Clock Distribution Concerns

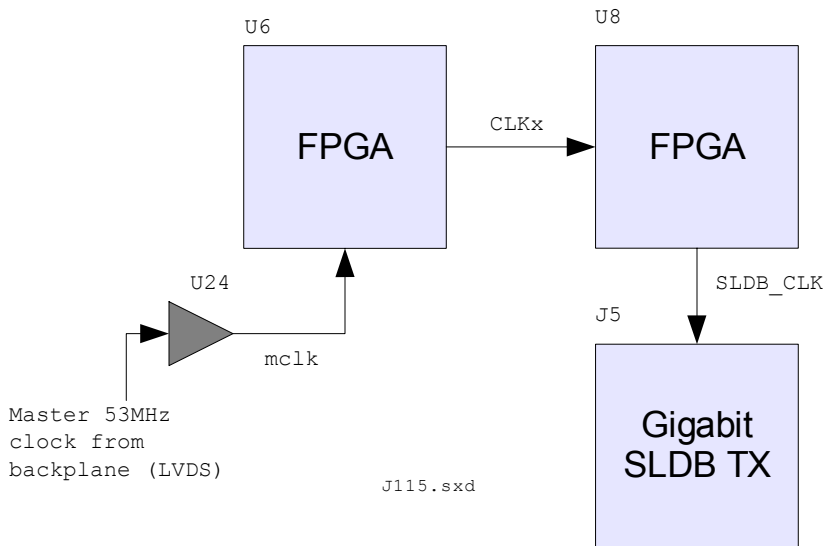
It appears that the Master 53MHz clock is run through several FPGAs like this:

What mechanism is in place to insure that excessive jitter and skew does not accumulate on this clock net as it passes through two layers of IBUFs, FPGA internal routing, DLLs, and OBUFS?

The AMCC device (S2042) used on the SLDB transmitter requires clock jitter less than +/-100 ppm.

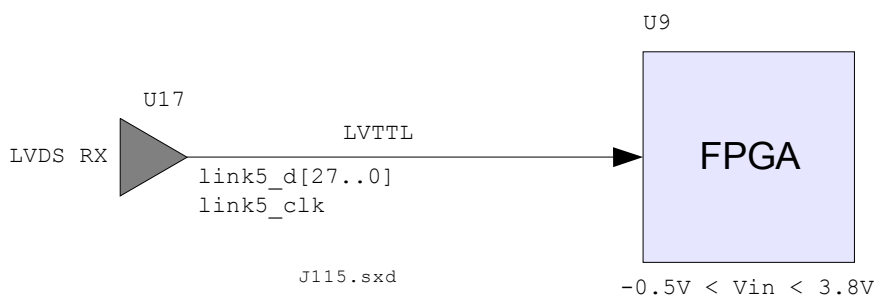
If there is noise on the +48V and +48VRTN lines it will be capacitive coupled into the experiment ground via C241, C242, C240, and C243. This may cause problems with the sensitive analog electronics nearby. We recommend that these capacitors should not be stuffed.
